Subject: Response to Letter Dated February 17, 1994

Reference: Docket 71-9019

This responds to your letter dated February 17, 1994, which requested additional information regarding GE's Consolidated Application dated December 3, 1993, seeking a revision to Certificate of Compliance USA/9019/AF for the Model No. BU-7 shipping container.

ATTACHMENT 1

FIGURE I

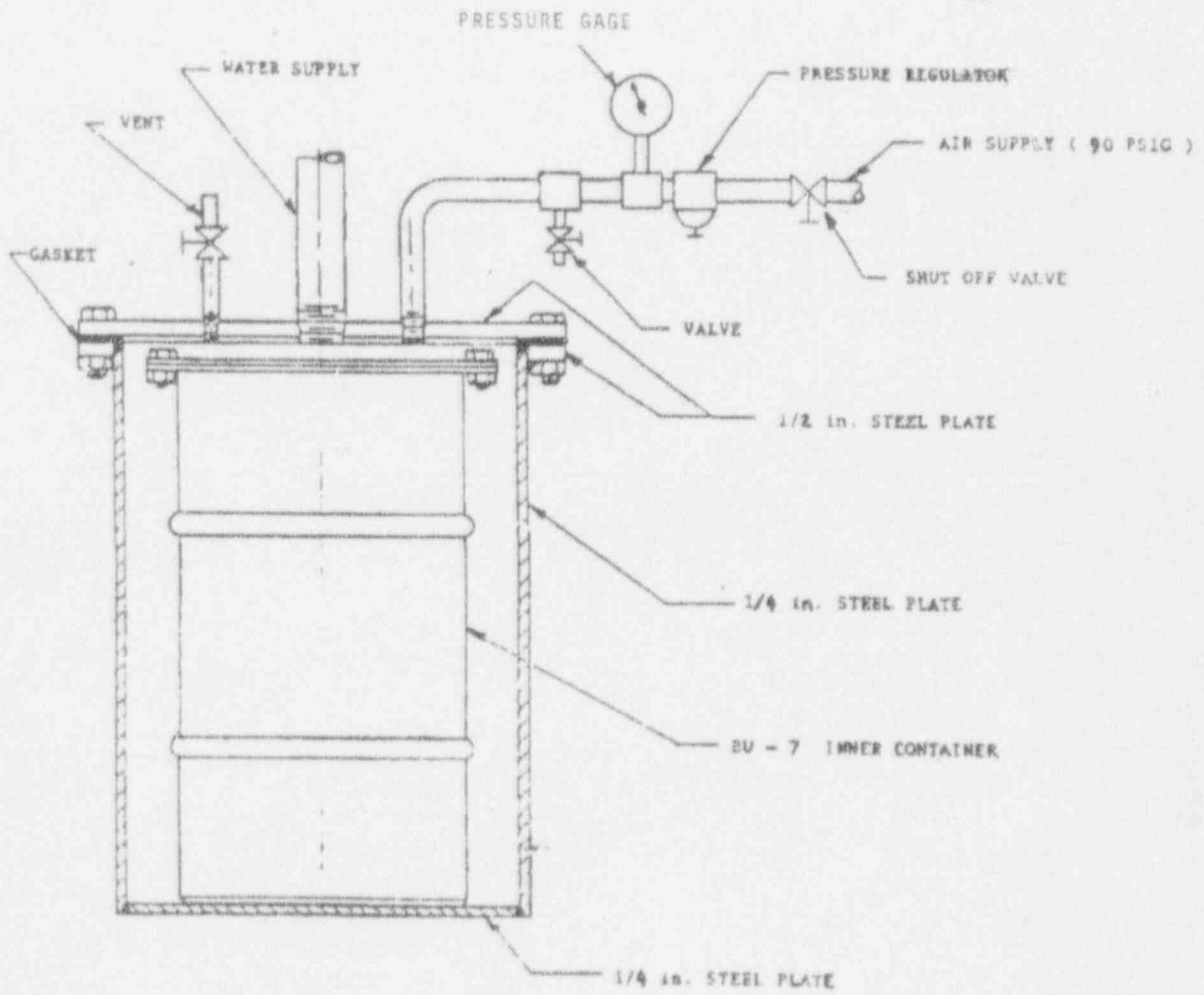
3. The application (supplements dated December 14 and 22, 1993) discusses hydrostatic tests that were performed on BU-7 and BU-J packages. The application is not clear with respect to the details of the tests. Revise the application to clearly address the following:
 - (a) Provide details of the hydrostatic tests performed on the BU-7 package. Include the package configuration, test setup, and package closure method.
 - (b) State whether the packages were newly fabricated or were packages which had been in service. Justify that the tests are representative of packages which are at the end of their service life.
 - (c) State how many specimens of each package type (BU-7 and BU-J) were tested. Note that Appendix B of the application dated December 3, 1993, states that only one BU-7 specimen was tested.
 - (d) Describe how the pass/fail demonstration was made.

Figure I attached defines the test set-up showing air supply valves, pressure gauge, water supply location, vent, configuration, etc. The package component tested in each case was a newly constructed 18-gauge inner container fitted with the specified 3/16" thick, 1-1/2" wide steel flange. Closure of the 3/16" thick steel lid was accomplished using a gasket and twelve 5/16-18 carbon steel bolts as specified for the package. The tests were performed on 18-gauge inner containers at a minimum pressure of 21.4 psig for 8 hours. In passing the test, there was no visual water in-leakage.

FIGURE III

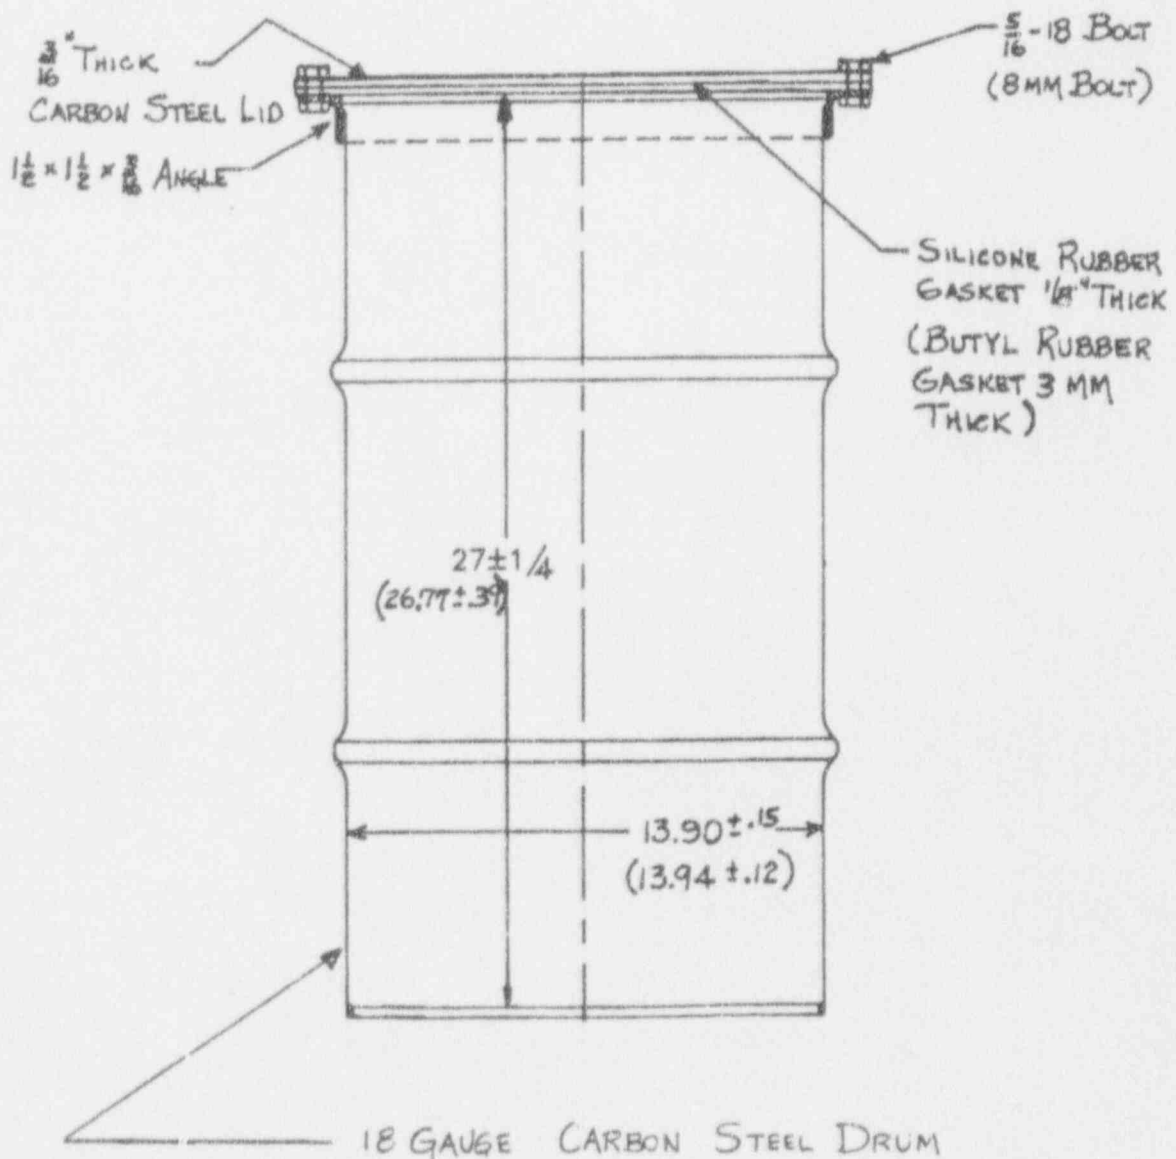
- (e) State how many specimens of each package type failed the test.
 - (f) Explain how the tests conducted on the BU-J package are relevant to the BU-7 package, considering any differences in the design, the dimensions, or the materials of construction.
- (a) The BU-7 hydrostatic tests discussed in GE's December 14 and 22, 1993, submittals were performed to satisfy Japanese registration needs, not NRC requirements. They were provided to the NRC as further substantial evidence of the 18-gauge inner container's leak tight design.

The BU-7 and BU-J 18-gauge inner containers are nearly identical as can be seen in Figure III attached. Both the BU-7 and BU-J use an 18-gauge minimum steel drum with two rolling hoops. The drum dimensions are near identical. The closure flange and lid are identical except for the size of the bolt closure holes and weld nuts. The closure bolts for the BU-7 are 5/16-18 (.313") carbon steel and for the BU-J are 8 mm (.315"). The BU-7 uses a silicone gasket with detailed specifications to assure its quality. The BU-J specifies only 3mm butyl rubber. The BU-7 closure procedure specifies prescribed torque requirements whereas the BU-J is silent on this point.

FIGURE IV

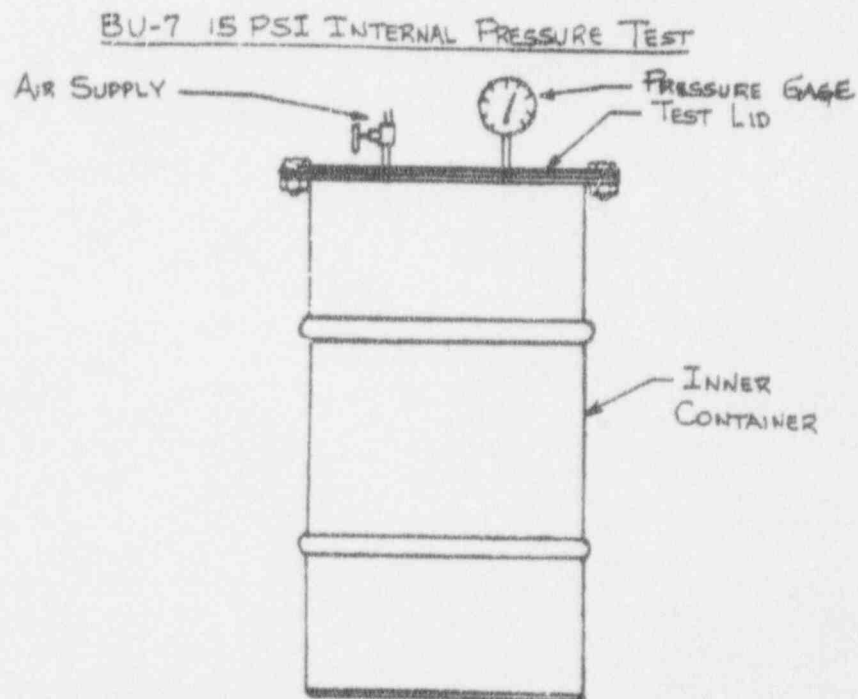
1. Describe the method used to leak test each inner container before its first use. Specify the sensitivity of the leak test and the criteria for accepting the inner container. Include a sketch of

the test set-up. Note that the leak test should be performed on the containment system as assembled for shipment, that is, all components of the containment system (drum, lid, and gasket) should be the components actually used for shipment. Also, the leakage flow direction during testing should be the same as in operation, i.e., into the inner container. Test methods using flow in the reverse direction should be justified.

The method used to leak test the inner containers prior to first use is described in Section 5.2.1 of the Consolidated Application. This test involves submerging in water the inner container under 15 psig internal pressure for at least one minute. During this time the container is observed for visible bubbles to determine whether any leaks exist. A sketch of the test set-up is attached (Figure IV).

FIGURE V

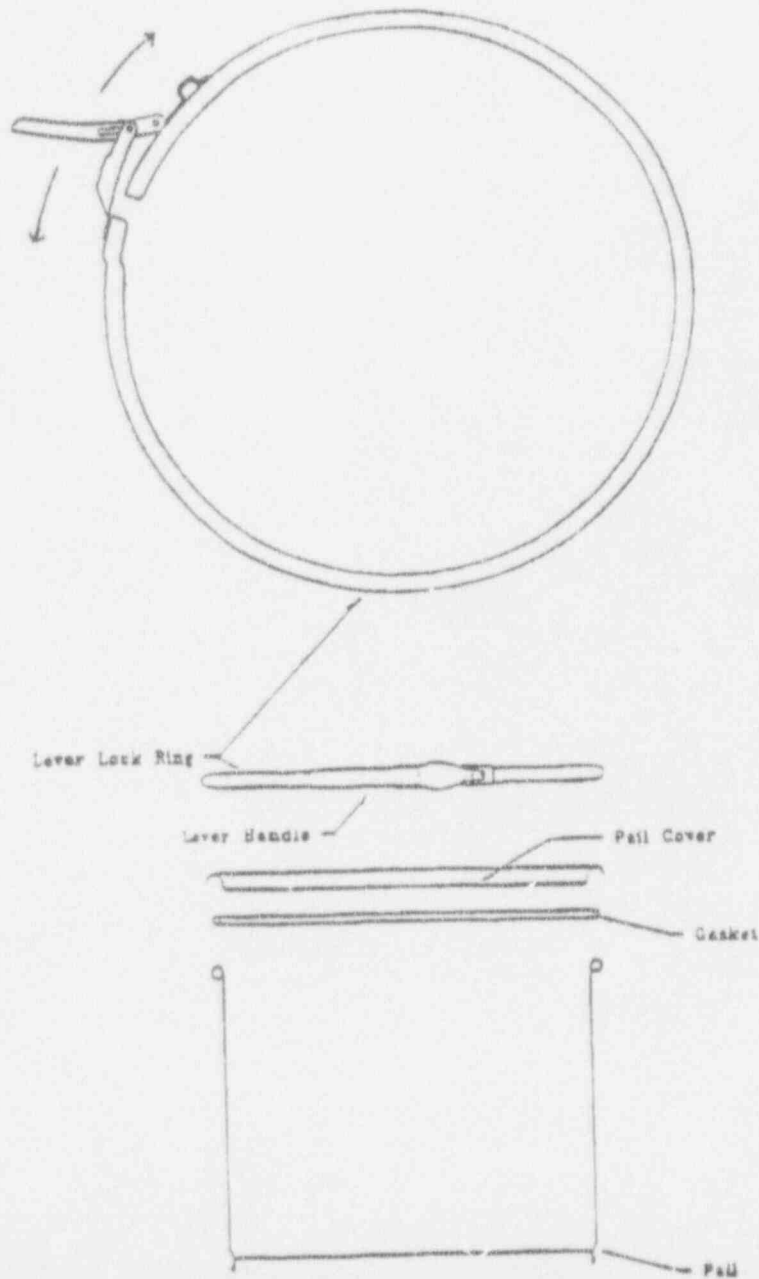
Provide drawings of the 3- and 5-gallon pails. Include the following information on the drawing: dimensions, tolerances, material specifications, applicable codes and standards for fabricating and acceptance testing the pails, and details of the pail closure.

codes and standards are contained in the above referenced ANSI standard and DOT regulation. The 24-gauge gasketed pail cover is held in place by a lever locking ring (see Figure V attached).

FIGURE 10 REV. 1 SUBMITTED 3/18/94

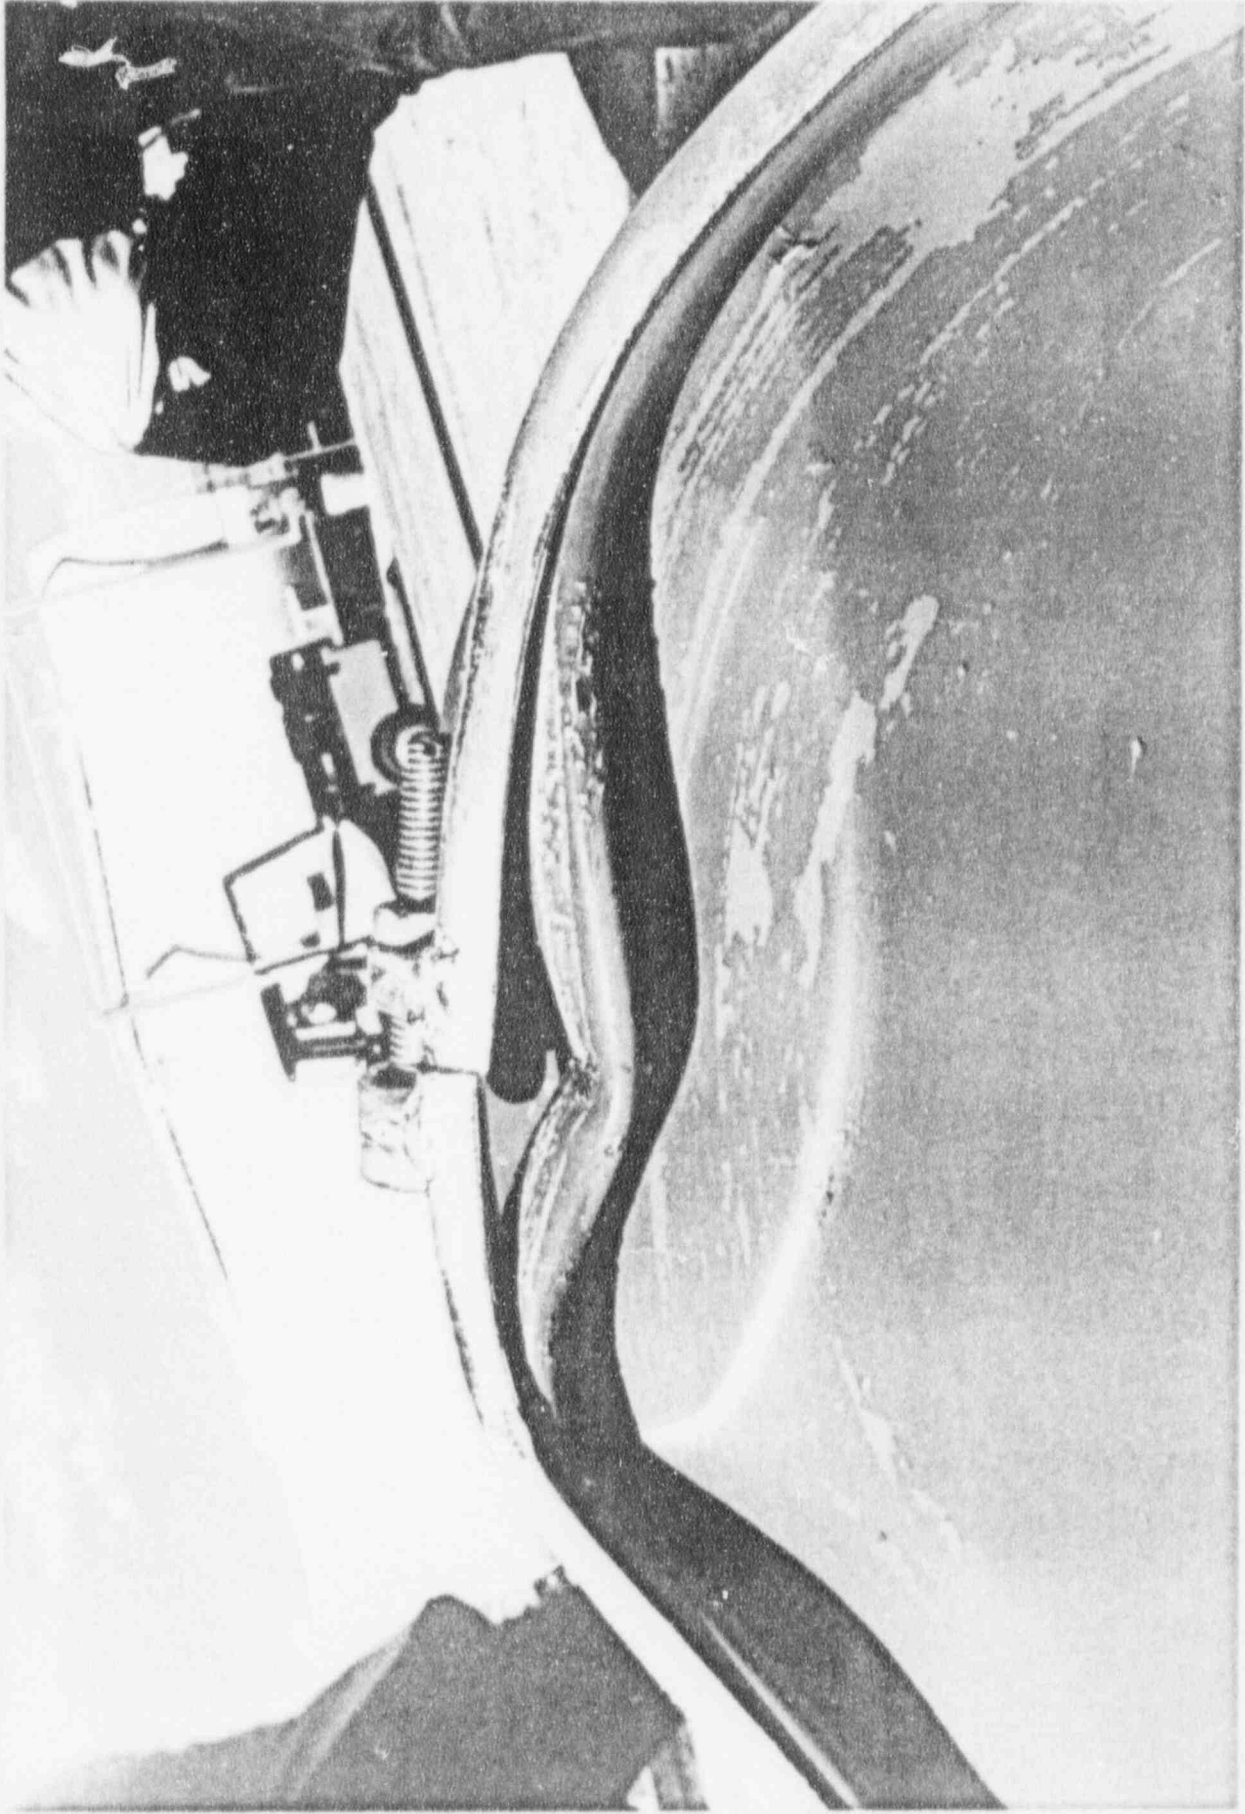
4. Figure No. 10 in Appendix B of the application is incorrectly labelled. It does not appear that this is a photograph of drum No. K-1878 (see, for example, Figure No. 11 in the same appendix). In Figure No. 10, the bolt which secures the drum locking ring appears to be broken. Provide a description of the damage sustained by this bolt. If possible, provide an additional photograph which clearly shows that the bolt did not break due to the 30-foot drop test.

GE has reviewed the report and it appears that Figure 10 is incorrectly labeled. Figure 10 more closely represents the damage done to the top of K-0174 (see Figure 18) and the report has been modified accordingly. Figures 11, 12, 13, and 14 allow easy identification as K-1878.

Figure 10 shows no breakage or damage to the closure bolt and the test engineer interviewed recalls none. The darkened area in question is a shadow as can be seen from the lighting in the photograph (cf the point of the closure ring at the nut location). In support of this position, GE has located two additional photographs from the photo sequence of the bolt on container K-0174 which more clearly show from two different perspectives that the bolt is not damaged. The photographs are enclosed and are being incorporated into the test report (Figures 10A and 10B) to avoid the ambiguity generated by Figure 10.

1. Appendix B, Figure 10, has been changed to show the BU-7 serial number as K-0174 instead of K-1878. Asterisks in the right-hand margin show the location of the changes. Also added to the new Figure is the date of this transmittal (3/18/94) and that this is Revision 1 of Figure 10.
